Aviation Safety Report

Ref 04.PA0045

REPORT REGARDING AVIATION SAFETY AT PROPOSED WASTE TO ENERGY PLANT

RINGASKIDDY, Co CORK

Appendix N Effect of Headwind on Climb Angle

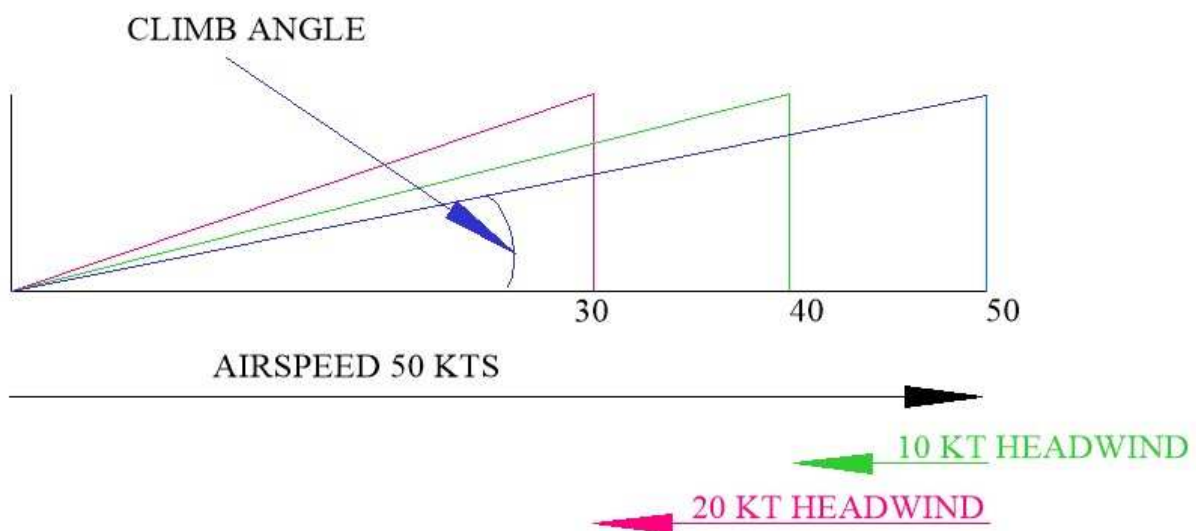
The diagram below shows the effect of a headwind on a climb angle. If the helicopter is flying at 50 kts with zero headwind and a rate of climb of 1,000 ft per minute, the climb angle will be as indicated by the blue line (approx. 11°). If the helicopter is flying at 50 kts airspeed but with a headwind of 10 kts, the ground speed will be 40 kts and the climb angle will be the green line (approx. 14°). If the helicopter is flying at 50 kts airspeed but a headwind on 20 kts, the ground speed will be 30 kts and the climb angle will be the red line (approx. 18°).

Appendix O Cork Harbour with 500 ft Radius Area and 500 meter Circles

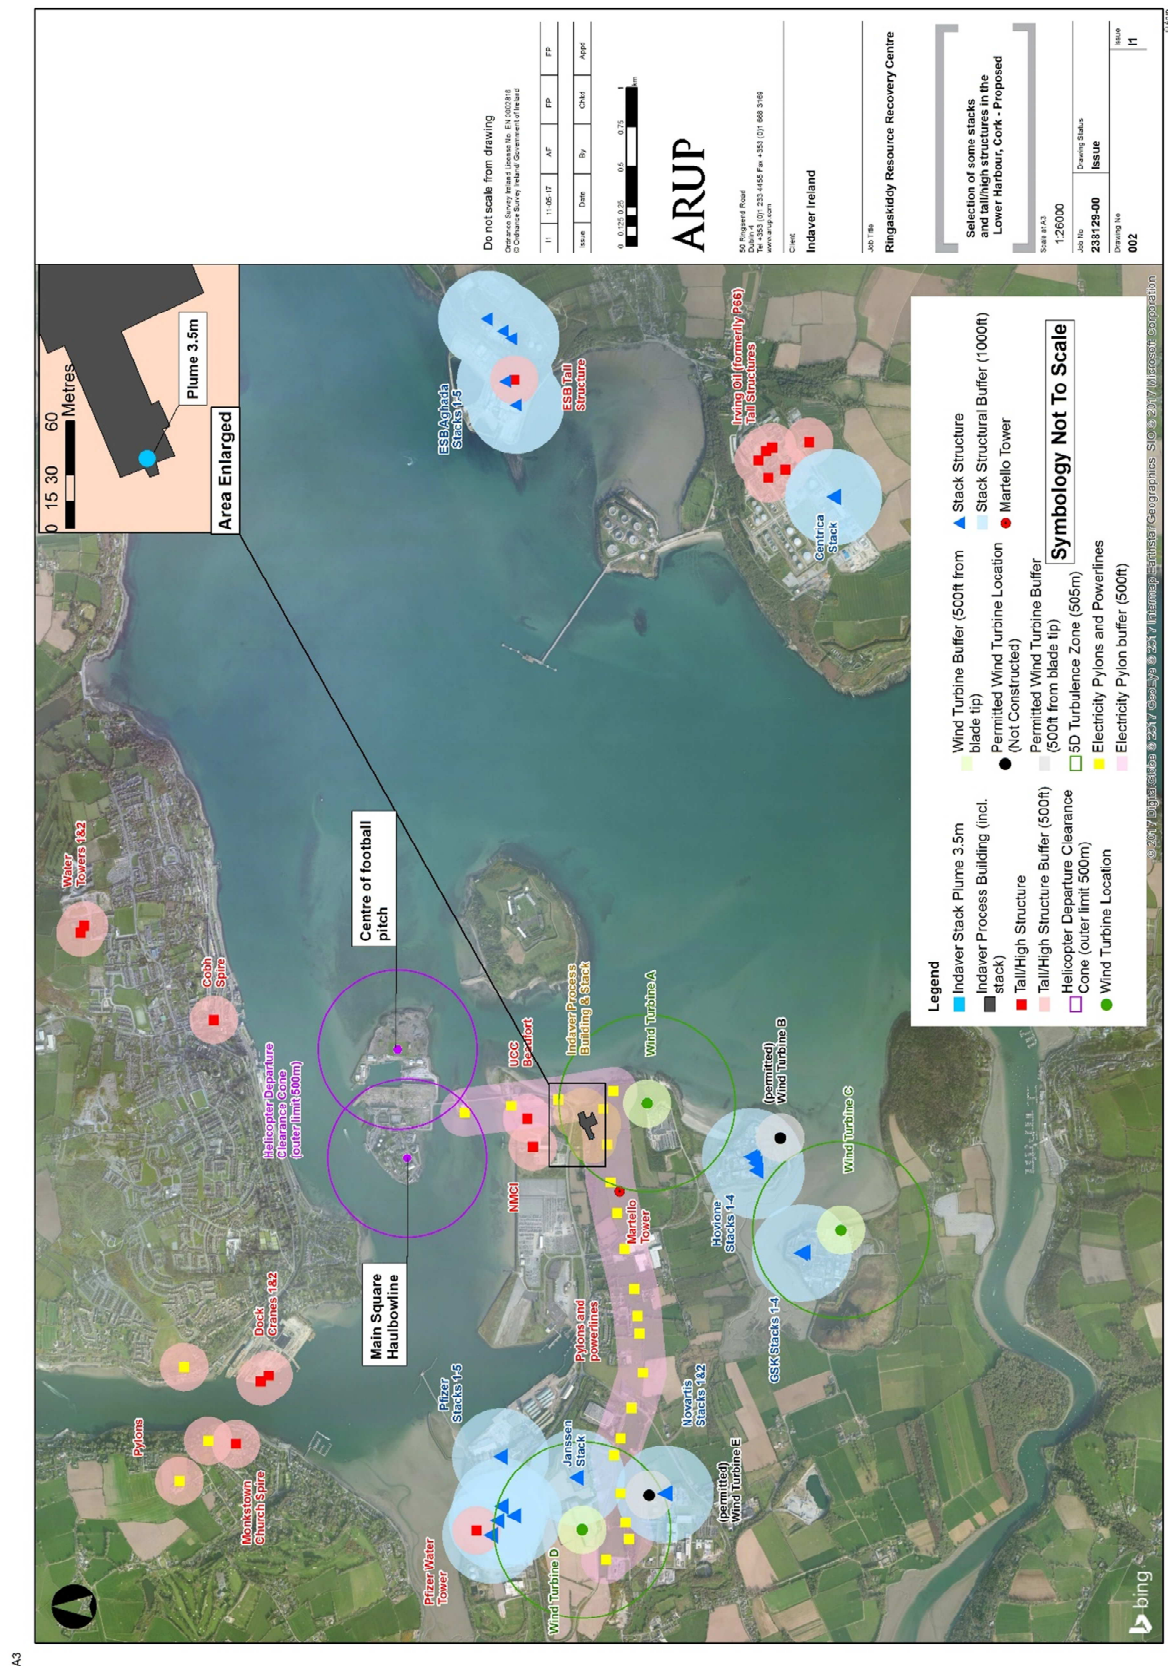
This Appendix shows all the significant obstacles in the Cork Harbour area, with an orange pink circle representing, to scale, the extent of a 500 ft obstacle clearance circle drawn around the top of the stack of the proposed plant. The Appendix also two green circles centres on the Main Square and the Football Field respectively. These circles have a radius of 500 meters and represent the limit of the 6° cone used by the UK Armed Services Joint Standards, which is used in helicopter operations as described in Para 6.4.16.3, et al, above. These circles are significant in that, within the circles, the 6° cone must be clear, and when the helicopter has reached the 500-meter circle, it is capable of turning in any direction to avoid obstacles outside the circle. The image shows that the pylon on Rocky Island is the only obstacle within these circles, and as show in Appendix P, it does not impinge into the 6° cone.

The 500-meter circle is also significant with regard to the circling recce, in that in the two cases noted in Para 6.4.4, (Quilty and Knockalough) the actual Air Crops recce circles were conducted within a 500-meter circle of the landing point, as opposed to the 800 – 1,000 meters claimed in the DOD submission.

The image shows the 3 existing wind turbines located in the sector south to west of the NS base and also 2 new turbines which has been granted permission.

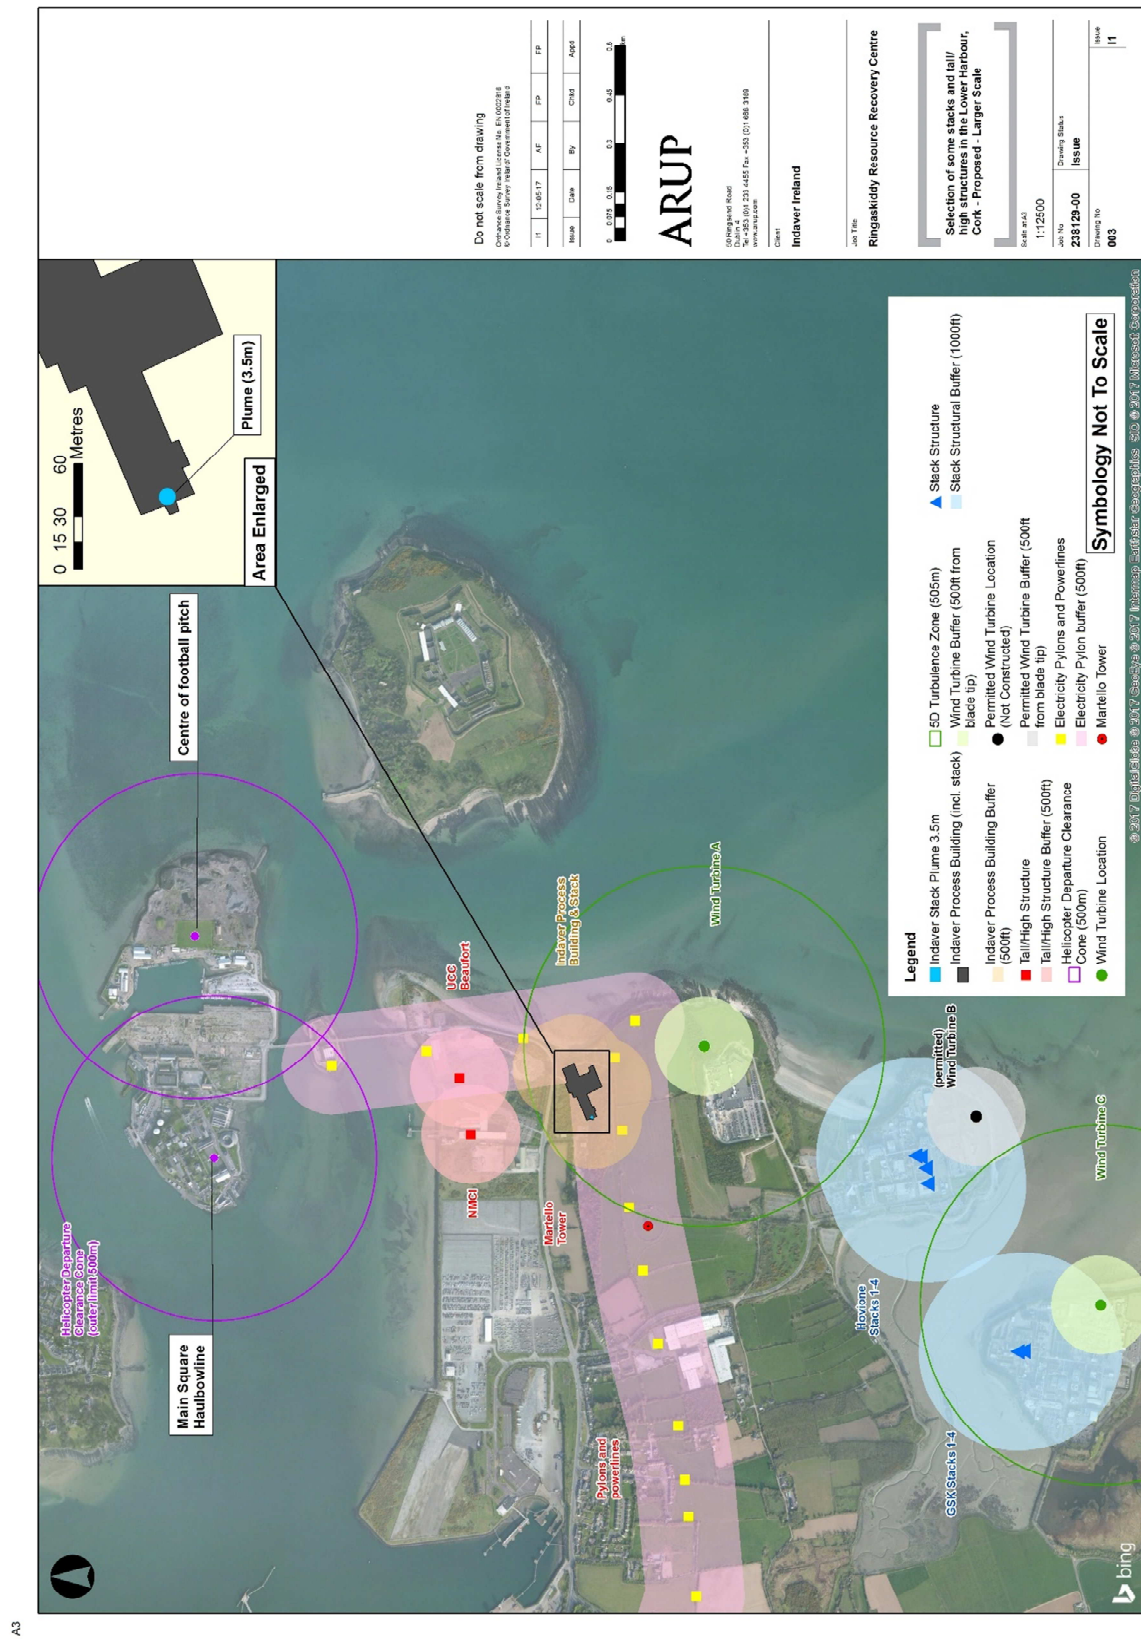
The next image shows the NS base area in close up, and clearly shows that a significant clearance exists between the 500 meter radius limits of the 6° clearance cone and the proposed plant, and between these radius limits and a 500 ft obstacle clearance area around the plant.

The inset in the top corner, is the proposed plant shown at an increased scale. The blue circle in this enlarged inset is the 3.5 meter radius circle showing the maximum possible extend of the possible dangerous area surrounding the top to the proposed stack, as discussed in Para 6.27.1. The corresponding small blue circle in the main diagram clearly shows the very limited extend of this danger area in relation to the NS base and other obstacles in the area.

Appendix Q Turbulent area due to wind turbine

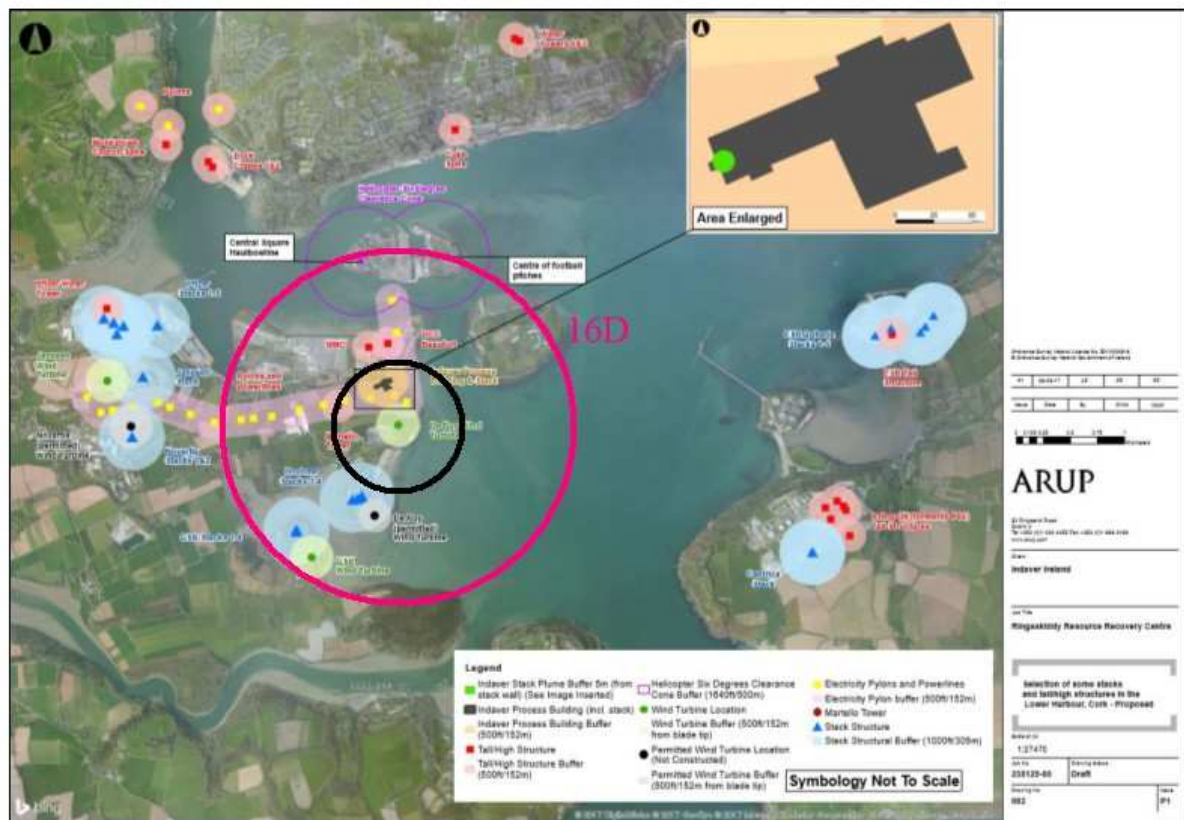
This image shows the horizontal limits of the turbulence zones from Wind Turbine A. The black circle indicates the 5D limit where dangerous turbulence can be expected, while the red zone indicated the 16D limit where turbulence can be expected. The 16D limit indicates and area where the turbulence would not be dangerous, but could be problematical when conducting underslung load operations.
